City Planning Commission  
Sacramento, California

- SUBJECT:**
- A. Negative Declaration
  - B. Tentative Map Time Extension to subdivide 3.9± net vacant acres into 31 townhouse lots and one common lot in the Single Family Alternative, Planned Unit Development (R-1A)(PUD) zone.
  - C. Special Permit to allow for a 31 unit townhouse development.

**LOCATION:** Northwest corner of Pocket Road and West Shore Drive

APPLC.NO. P87-131

# EXHIBIT C

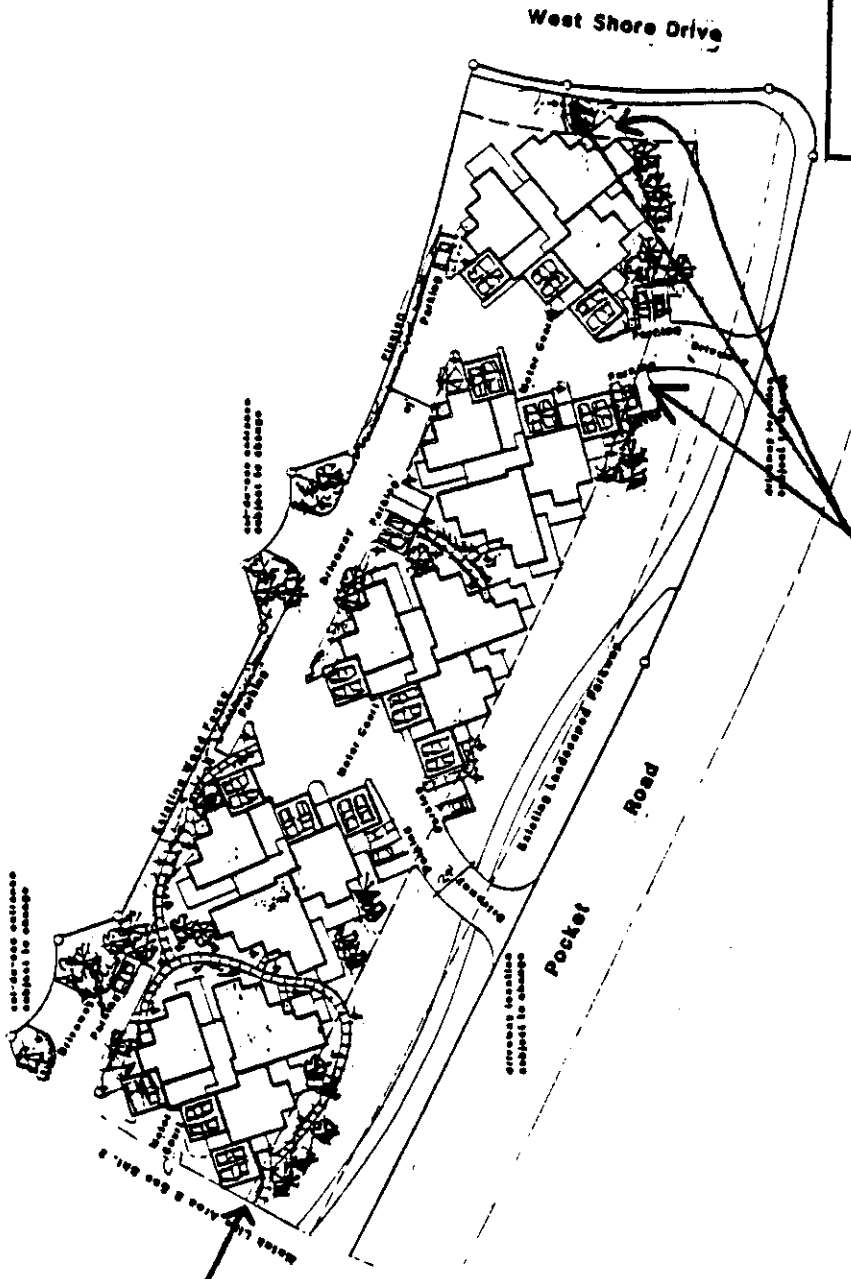
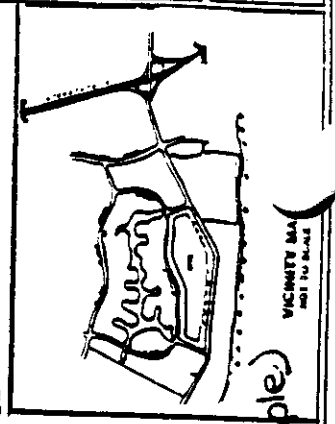
Several of the private patios for the residential units are indicated in the linear parkway (Exhibit C). These patio areas and any patio walls or fences must be located out of this required landscaped setback area.

Fifty (50) parking spaces are required for the proposed development. The applicant is providing 31 two-car garages (62 spaces) and 26 guest parking spaces. This number exceeds the minimum amount of parking required. Eight of the guest parking spaces are located in the linear parkway (Exhibit C). These spaces will need to be relocated out of the parkway or removed.

Remove all parking,  
patio areas and  
private walks leading to  
public right-of-way  
from linear parkway  
and landscaped setbacks (example)

- a. All parking spaces, patios, patio walls and/or fences and walkways connecting residential units with the public right-of-way shall be relocated outside of the linear parkway and any required landscape setback or eliminated from the site plan.

C-2

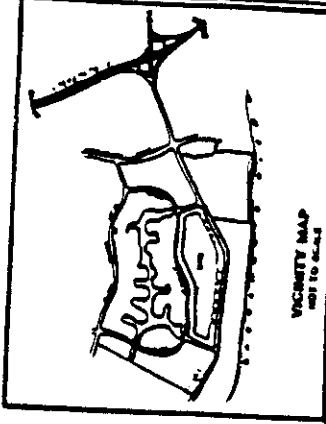
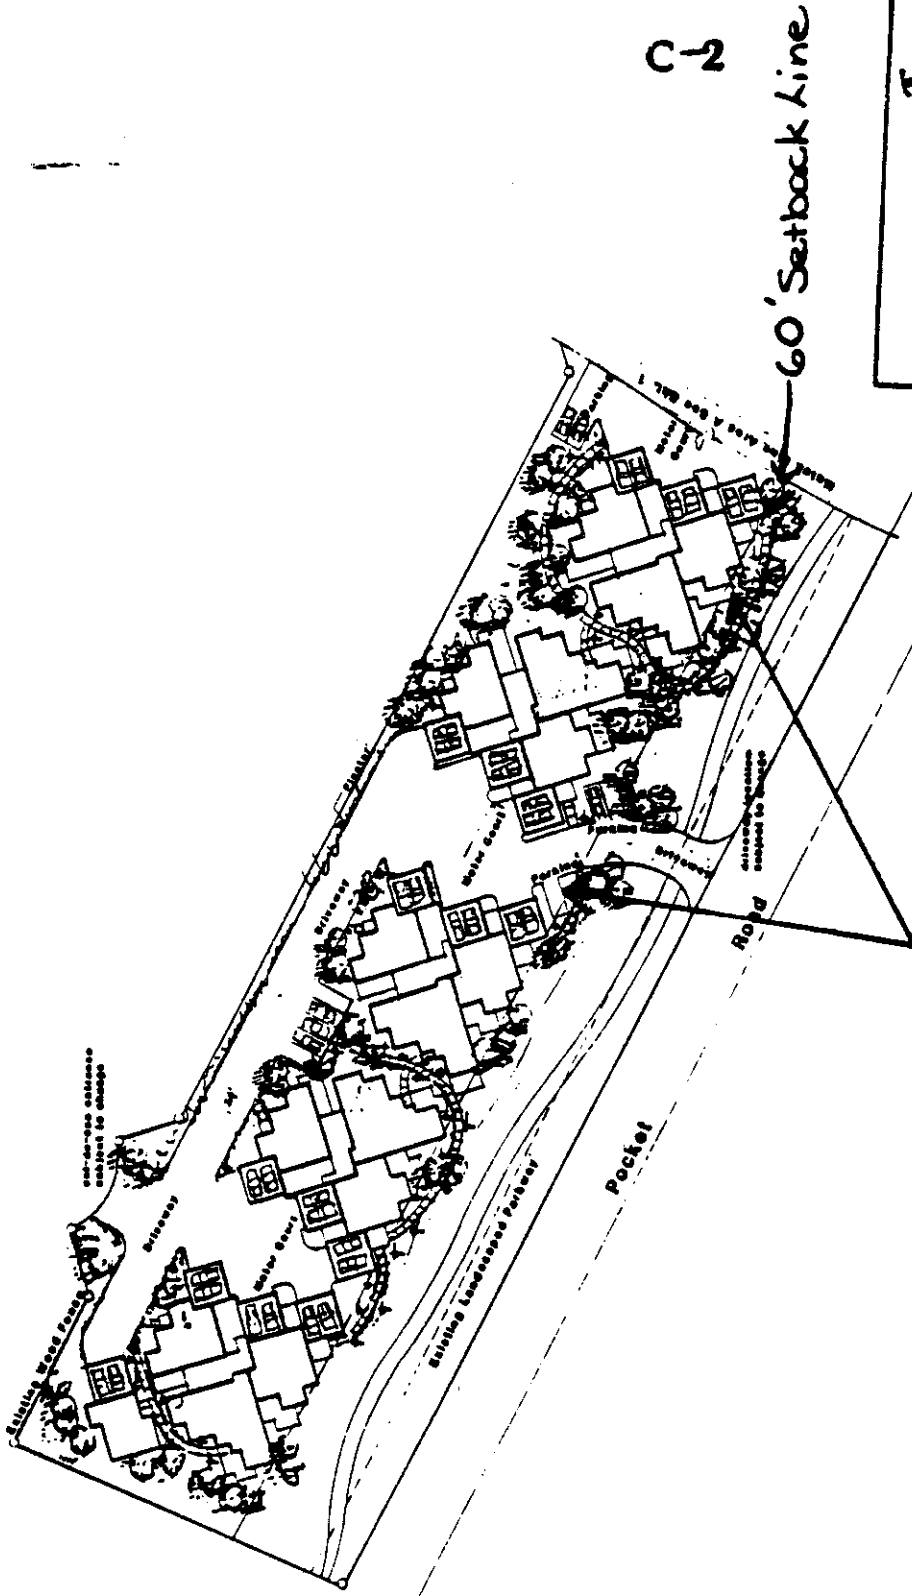
Remove all parking and patio areas from linear parkway (example)

# TYPICAL BUILDING CLUSTER

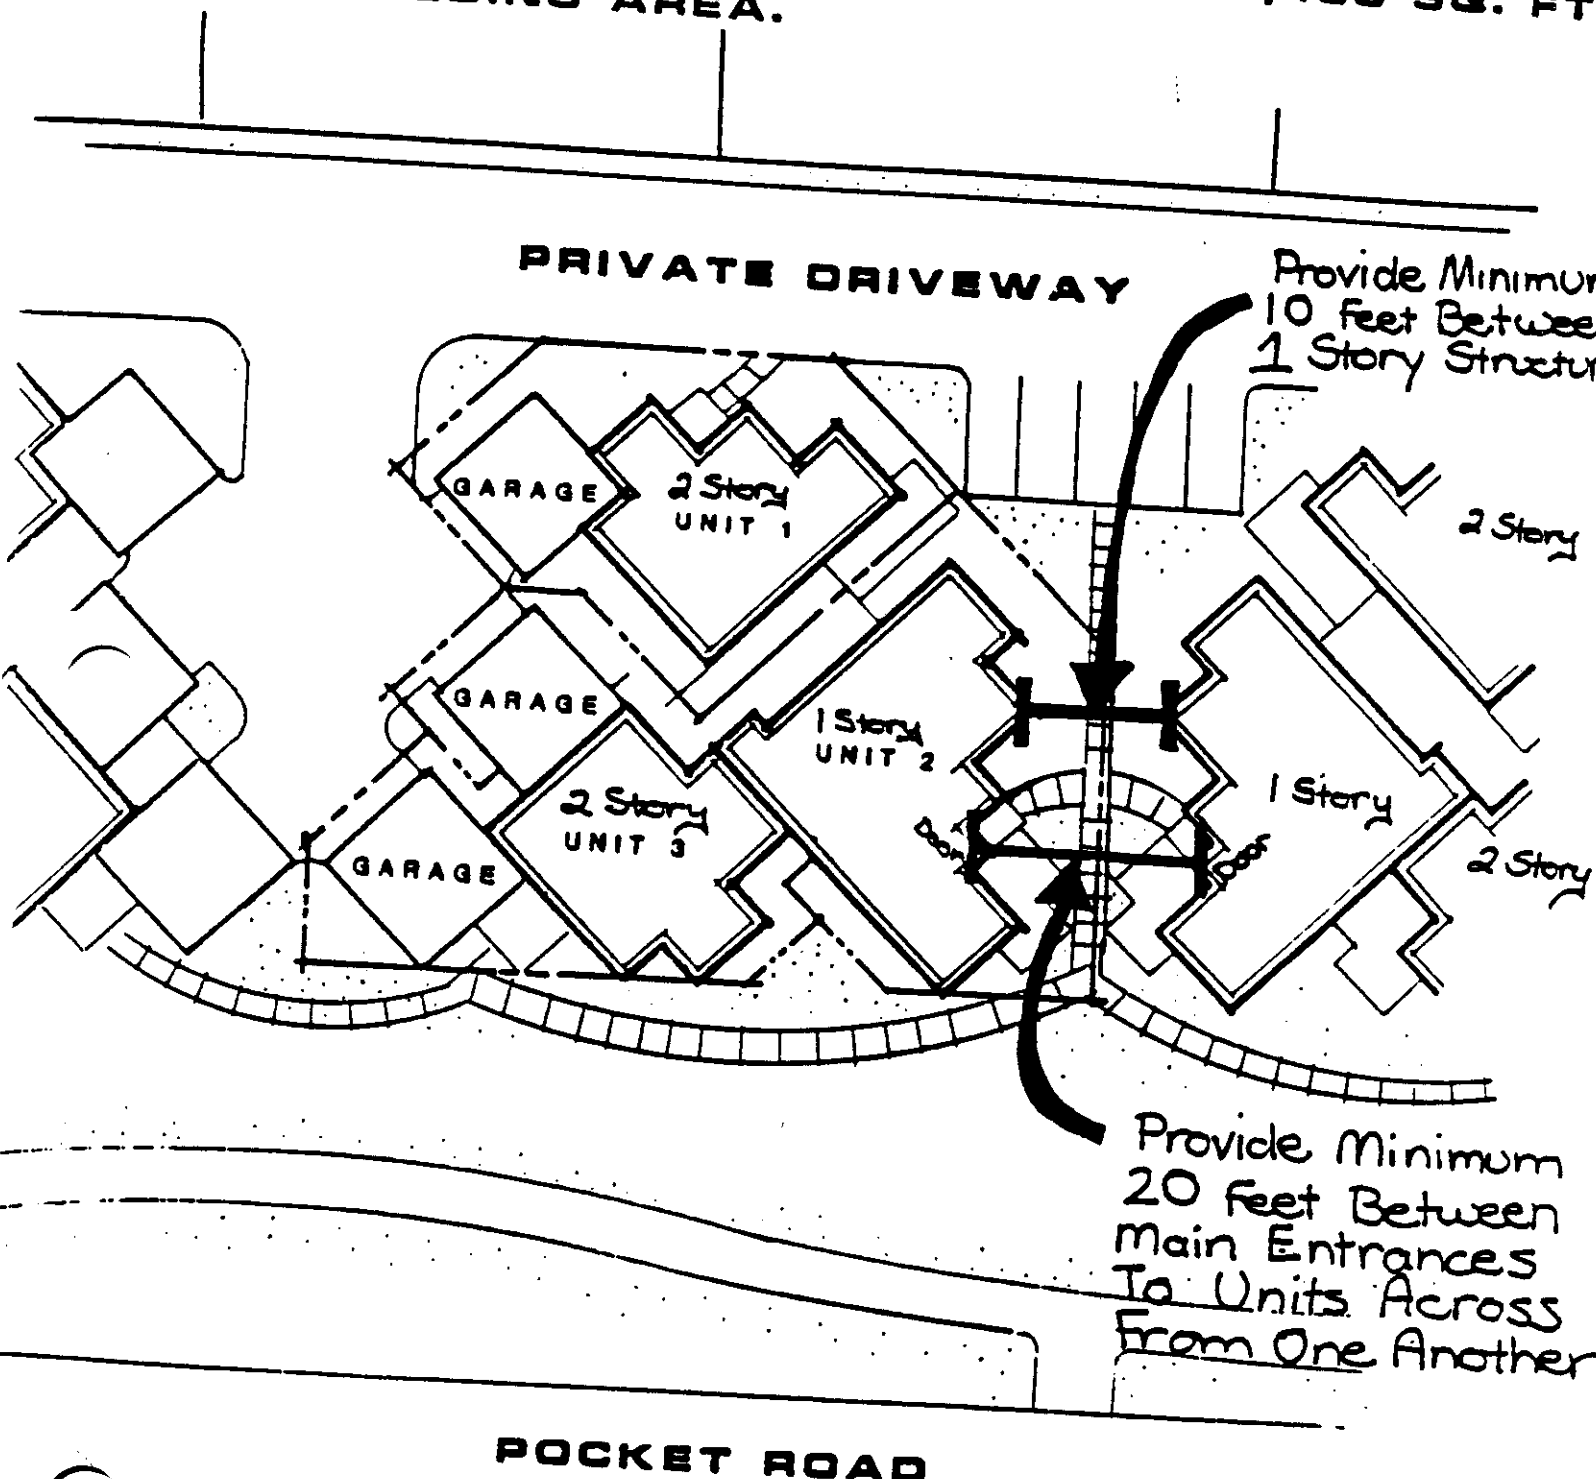
Overall, planning staff finds the site plan to be innovative and well-designed. Staff recommends that a minimum five-foot landscape setback, 10-foot building setback and six-foot high solid fence be provided along the north property line to provide privacy to future residents of the adjacent single-family subdivision. A minimum of 10 feet between the one-story portion of the building clusters should be provided in order to provide adequate access to the units and prevent a canyon effect from occurring between clusters. Twenty feet between the main entrances to units across from one another should also be provided (Exhibit F).

- d. A minimum of 10-foot building setback shall be provided adjacent to the north property line.
  - e. A minimum of 10 feet shall be provided between the one-story portion of the building clusters and a minimum of 20 feet between the main entrance units across from one another, shall be provided as shown in Exhibit F.
